# UNITED STATES PATENT AND TRADEMARK OFFICE

APPLICATION NO.	FILING DATE	FIRST NAMED INVENTOR	ATTORNEY DOCKET NO.	CONFIRMATION NO.
10/771,999	02/04/2004	Nathan Taylor	NATNAN P01AUS	5161
20210	7590	06/29/2006	EXAMINER	
DAVIS & BUJOLD, P.L.L.C. 112 PLEASANT STREET CONCORD, NH 03301			PAHNG, JASON Y	
			ART UNIT	PAPER NUMBER
			3725

**Office Action Summary**

## **DETAILED ACTION**

FIG. 1

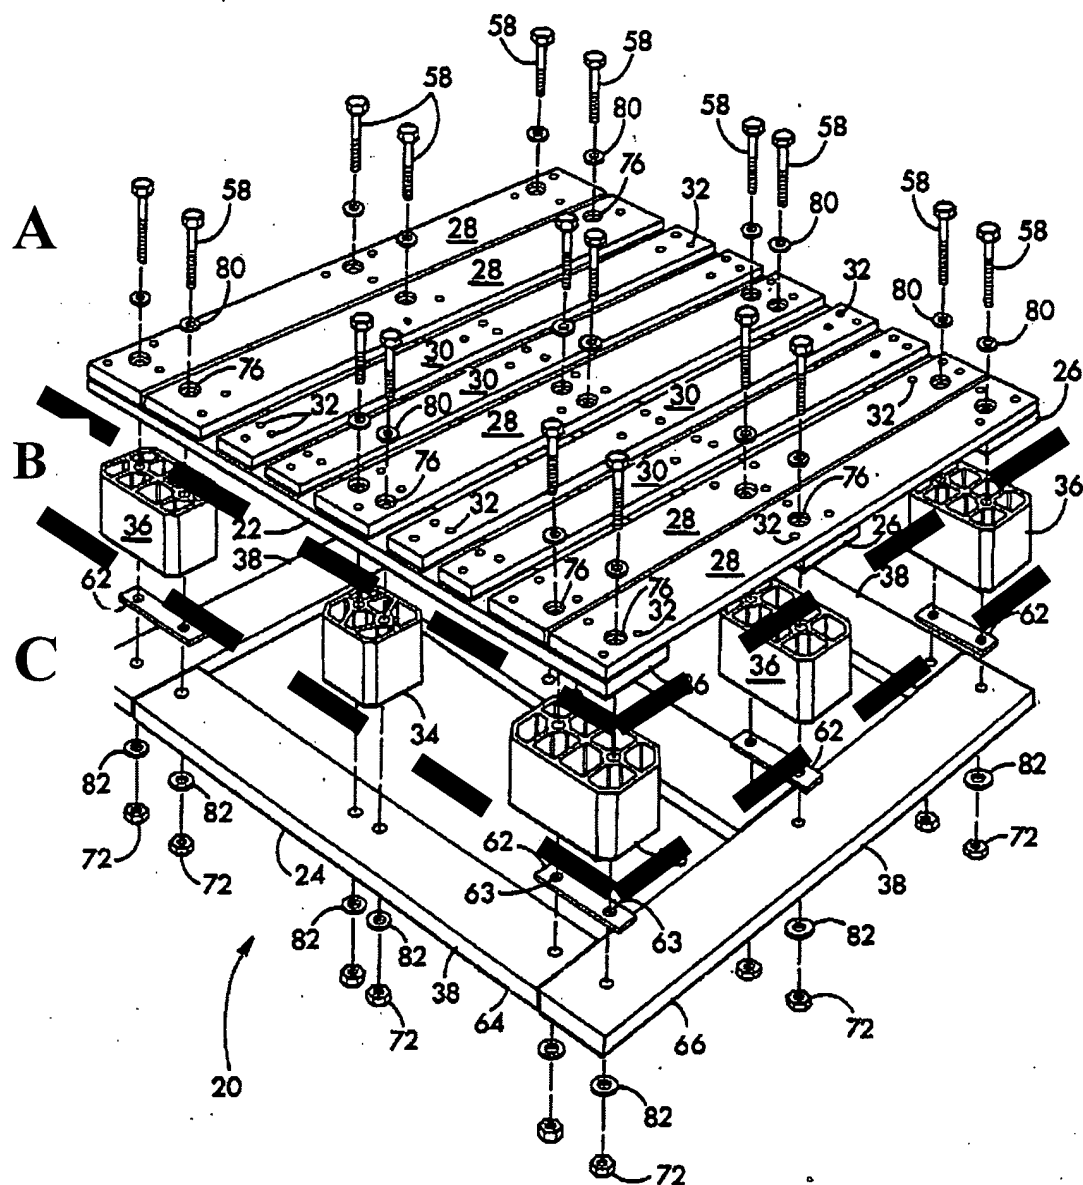
With regard to claim 1, Breezer discloses a mold capable of being expanded including:

1. a plurality of separate mold sections (A, B, C, modified Figure 1 below) comprising a bottom section (C, modified Figure 1 below) and a top section (A, modified Figure 1 below) defining a sidewall extending therebetween (modified Figure 1 below);
2. the sections are secured together by a releasable fastening mechanism (58).

With regard to claims 2 and 8, Breezer discloses a passage defining a throughbore (Figure 1).

With regard to claim 3, Breezer discloses an intermediate mold section (B, modified Figure 1).

With regard to claim 4, Breezer discloses a first mold defined by the bottom section (C, modified Figure 1) and the top section (A, modified Figure 1). Breezer also discloses a second mold defined by another separate mold section (B, modified Figure 1) in addition to the first mold.

With regard to claim 5, as well as can be understood, Breezer discloses a mold section comprising a substantially planar top and bottom surface (Figure 1).

With regard to claim 6, Breezer discloses a top surface of each mold sections having a top edge profile substantially matching a lower edge profile of the next adjacent mold section (Figure 1).

With regard to claim 7, as well as can be understood, Breezer discloses a top surface of each mold section aligned with a bottom surface of an adjacent mold section (Figure 1). The sidewall portions of mold sections define a mold sidewall (Figure 1).
